RECEIPT DATE: 12/18/24 **ONSITE SEWAGE DISPOSAL SYSTEM** P 587903

APPROVAL DATE: 4/3/2025 (SP) **PERMIT: NEW CONSTRUCTION** A _____

PROPERTY ADDRESS: 548 Watersville Road

SUBDIVISION: Hay Meadow Overlook LOT: 3 TAX ID: _____

* Approved supplemental plan
 due to issues encountered w/ excessive
 rock w/in sdt. Engineer
 As built to follow -KMW

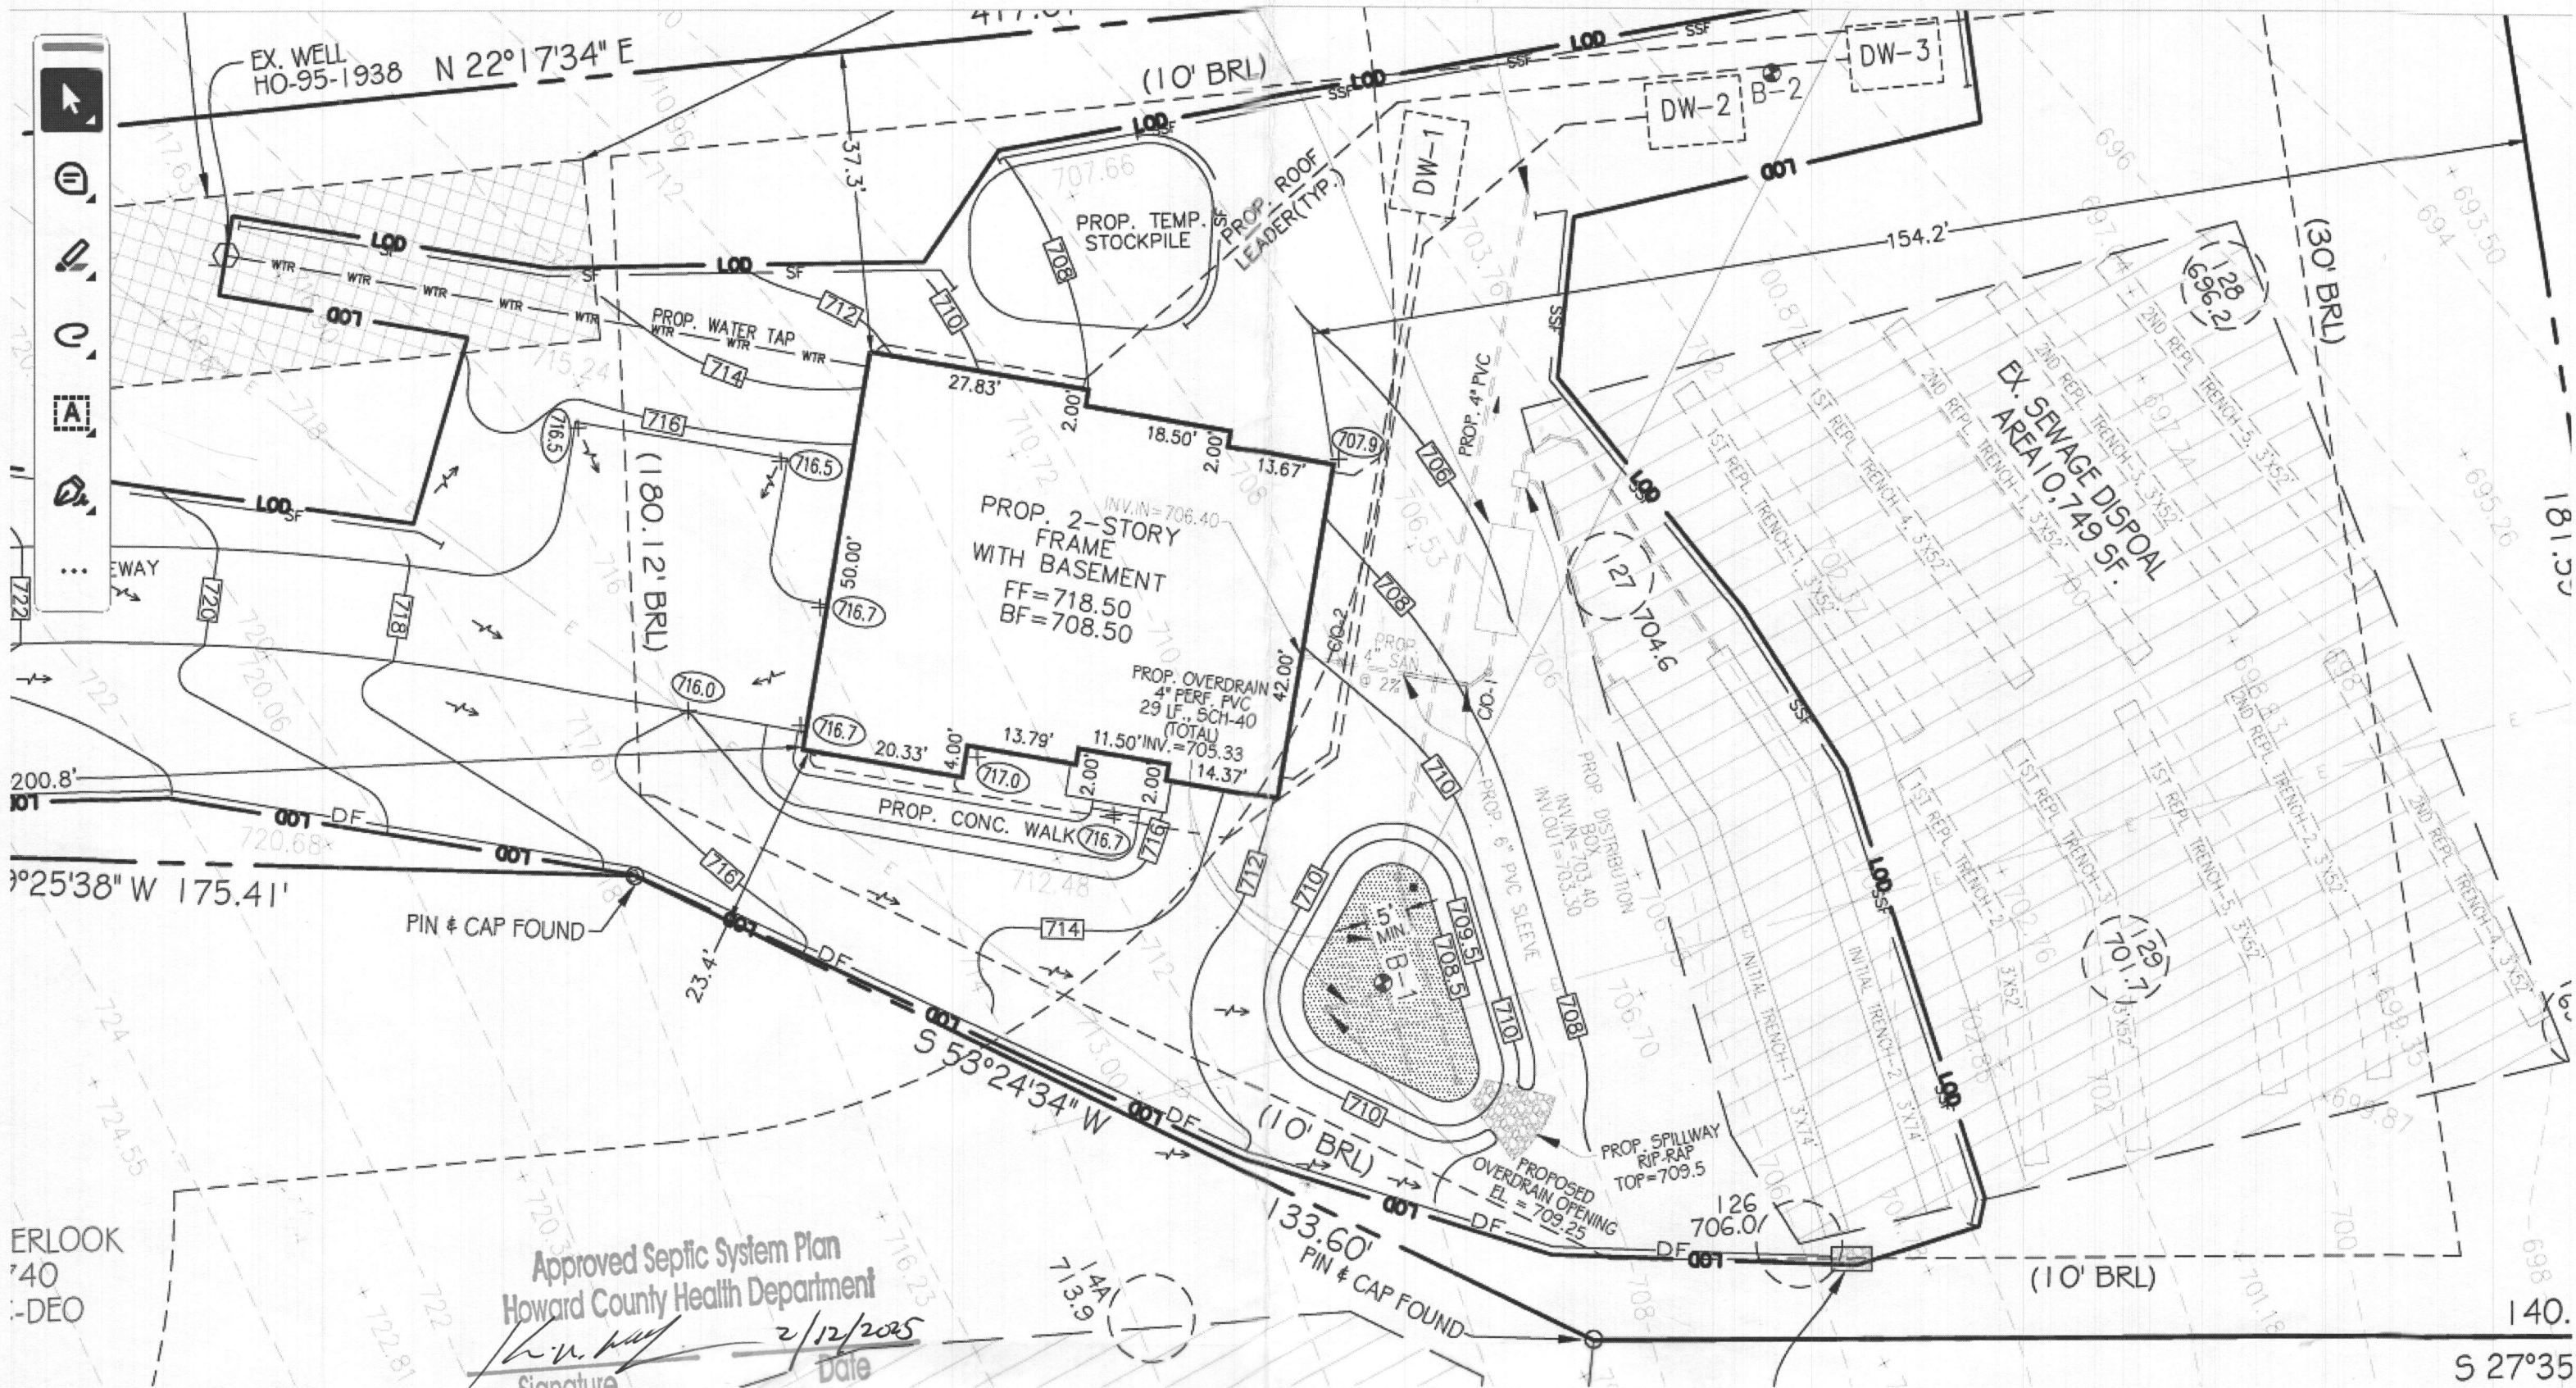
So I met with my Director and we have come to a solution that will keep the install moving forward. After review of the site evaluation on Wednesday and comparing that with the original notes from the subdivision, we will keep with a conventional trench design that will be consistent with current regulations while maximizing design standards. The system will be shallower than originally proposed and will also increase the loading rate from 0.8gpd/ft² to 1.2gpd/ft². This is mainly due to the increased permeability with increasing depth to rock on the site; hence why we are shallowing up the trench bottom from 7 feet to 5 feet.

I would keep the system inlet shallow as possible. I spoke with Dan (Freedom Septic) and he confirmed that he can make a 2.5 foot inlet invert on the trenches. Ideally, we would like to utilize 2 trenches, keeping them close to perc hole 126, southeast part of the sda.

What we would need from Nj is a supplemental sheet showing the new design calculations followed by an as-built plan once the system is installed.

The design specifications are as follows:

Loading rate → 1.2gpd/ft²

Trench bottom → 7 feet

Effective area start depth → 3.5 feet

Total trench length required → 148 feet

SEPTIC SYSTEM CALCULATIONS, INITIAL SYSTEM	SEPTIC SYSTEM CALCULATIONS, 1ST + 2ND REPLACEMENT SYSTEMS
ABS. RATE= 1.2, EFFECTIVE DEPTH= 3.5'-5' = 1.5'	ABS. RATE= 0.6, EFFECTIVE DEPTH= 3'-5' = 2.0'
DRAINFIELD AREA: 5 BEDROOMS AT 750 gpd / 1.2 ABSORPTION RATE=625 SQ. FT.	DRAINFIELD AREA: 5 BEDROOMS AT 750 gpd / 0.6 ABSORPTION RATE=1250 SQ. FT.
SIDEWALL REDUCTION CREDIT: $\frac{WIDTH+2}{WIDTH+1+2(DEPTH)} = \frac{3+2}{3+1+2(1.5)} = \frac{5}{7} = 0.714$	SIDEWALL REDUCTION CREDIT: $\frac{WIDTH+2}{WIDTH+1+2(DEPTH)} = \frac{3+2}{3+1+2(2)} = \frac{5}{8} = 0.625$
LENGTH OF TRENCHES: $\frac{625 \times 0.714}{3} = 148$ LINEAR FEET	LENGTH OF TRENCHES: $\frac{1250 \times 0.625}{3} = 260$ LINEAR FEET
INITIAL SYSTEMS: TWO TRENCHES OF 74 FEET IN LENGTH EACH, 3 FEET WIDE, 10 FEET MINIMUM SPACED ARE PROVIDED.	REPLACEMENT SYSTEMS: FIVE TRENCHES OF 52 FEET IN LENGTH EACH, 3 FEET WIDE, 10 FEET MINIMUM SPACED ARE PROVIDED.
